Lyons Quarry M-1977-141 Technical Revision 4 Addendum

Project: Lyons Quarry Reclamation – Phase II Floodplain

Subject: Addendum to Technical Revision 4 for Permit M-1977-141 Lyons Quarry Reclamation Plan

SHEET
01C-05

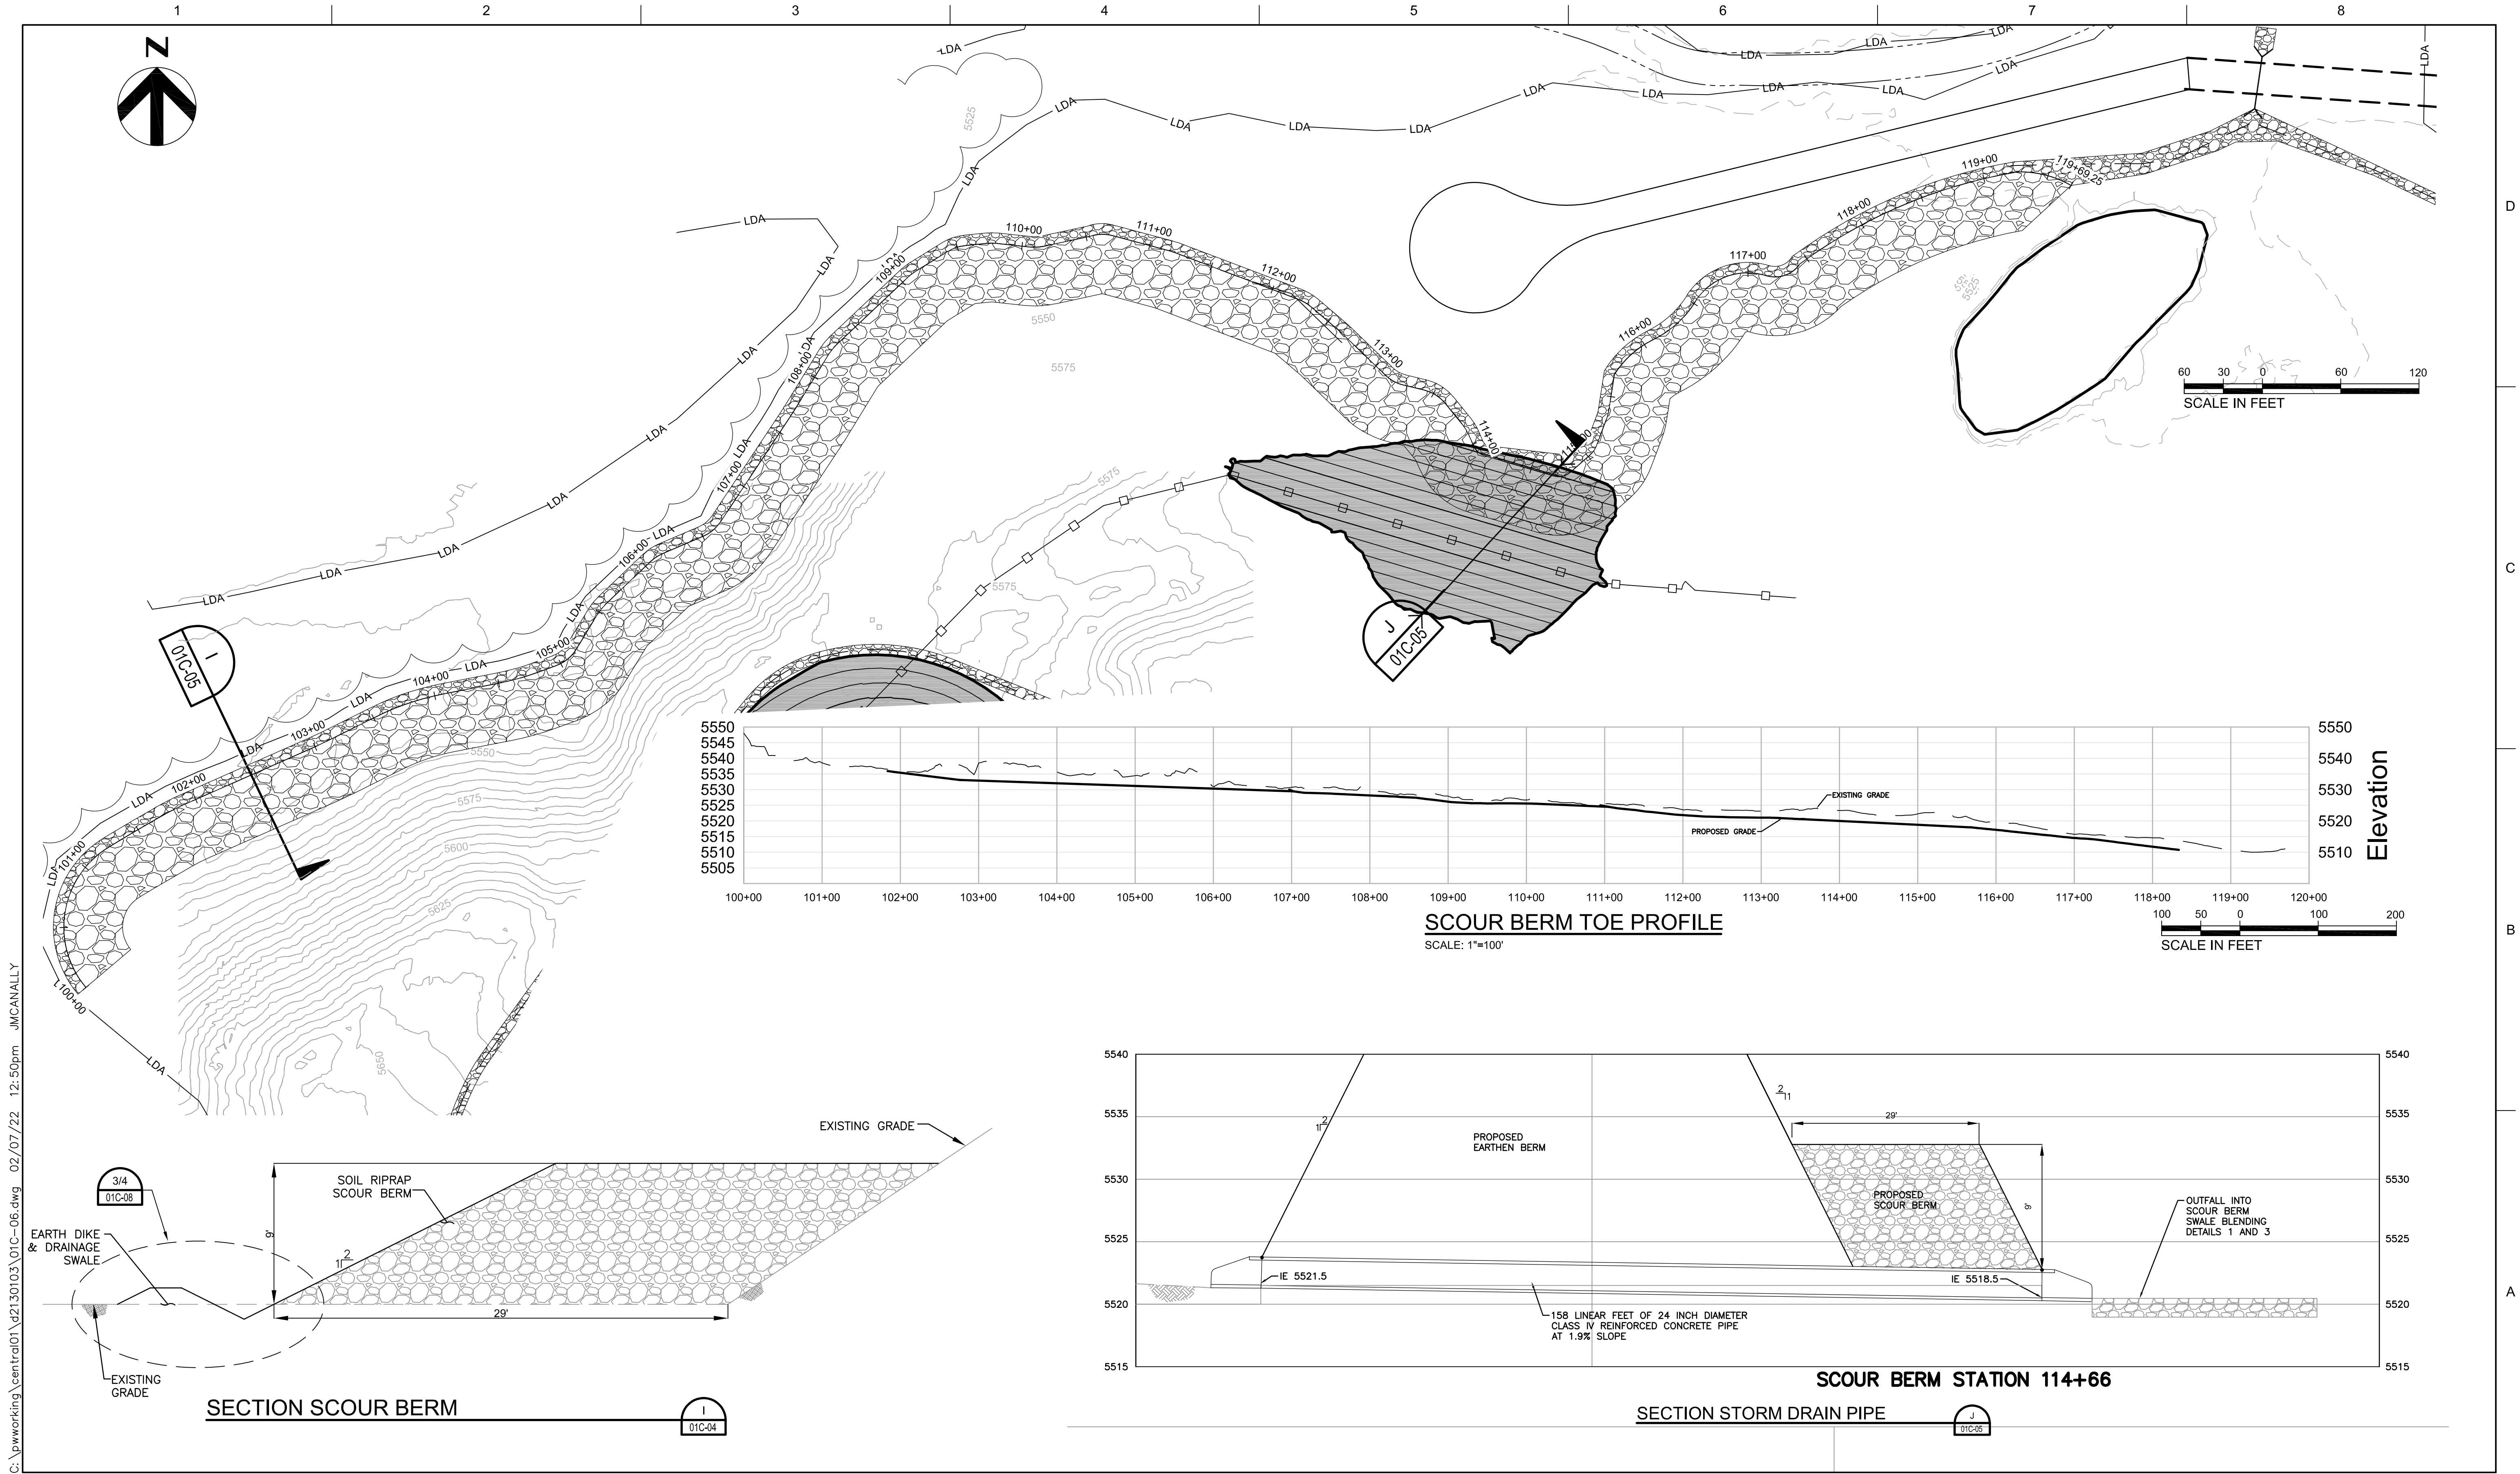
- Sheet C-02
 - Removed the floodplain fill quantity and updated total. The previous floodplain cut quantity did not include the over excavation for the soil riprap.
- Sheet C-05
 - Updated detail number callouts
- Sheet C-06
 - Added proposed scour toe profile based on the Boulder County South St. Vrain 30% design concept grades and minor detail revision. The new profile will result in additional cut along the scour berm. Scour berm now to be constructed using soil riprap with material sourced onsite.
- Sheet C-08
 - Removed coir matting detail and added the scour berm foundation detail
- Sheet C-09
 - Revised hatching and updated area table

SHEET
01C-06

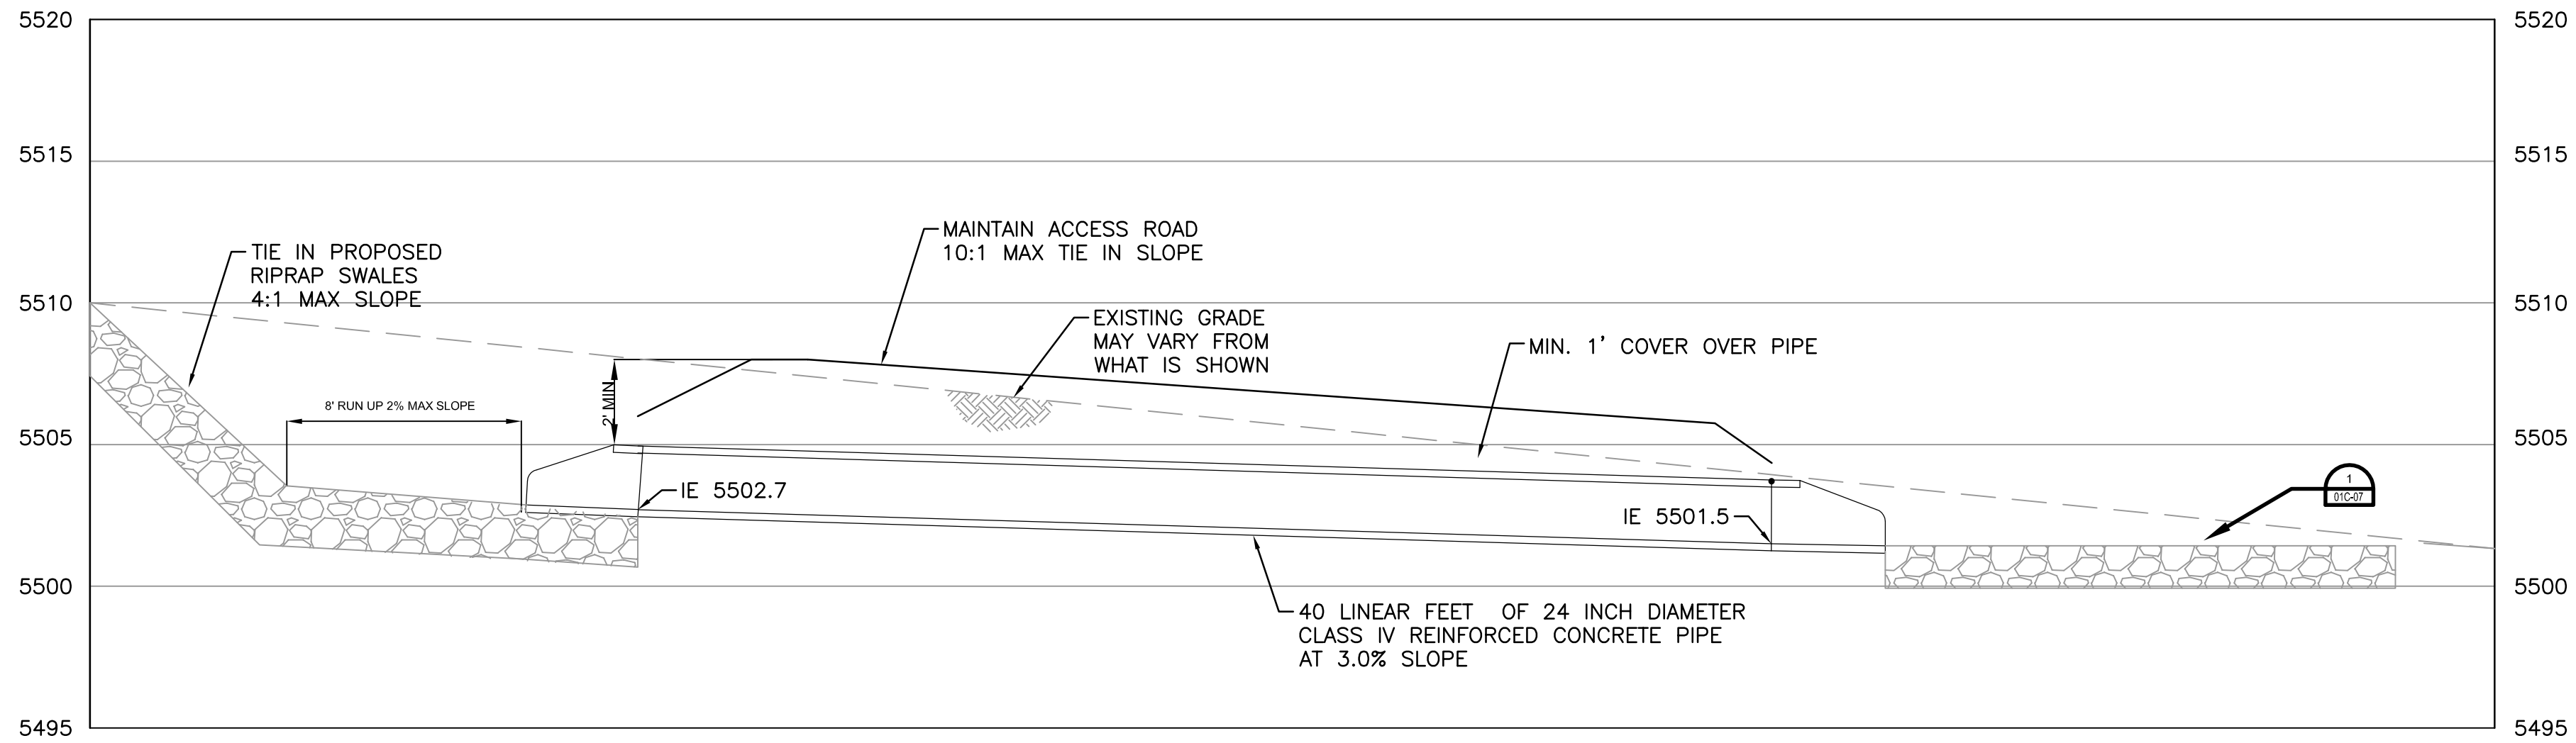
When it comes time to implementing the section of the scour berm with the boulder toe, we request that our engineer (Prashant) be included in observing field conditions. Based on observed conditions, we may request just a bit more depth to the toe using onsite material than is shown in the detail just to ensure a connection with the shallow bedrock. Our desire is to create long term stability of the berm and the planned creek alignment in the area where the planned alignment comes closest to the berm (i.e., in the vicinity of STA 109+00). Would you all be amenable to that?
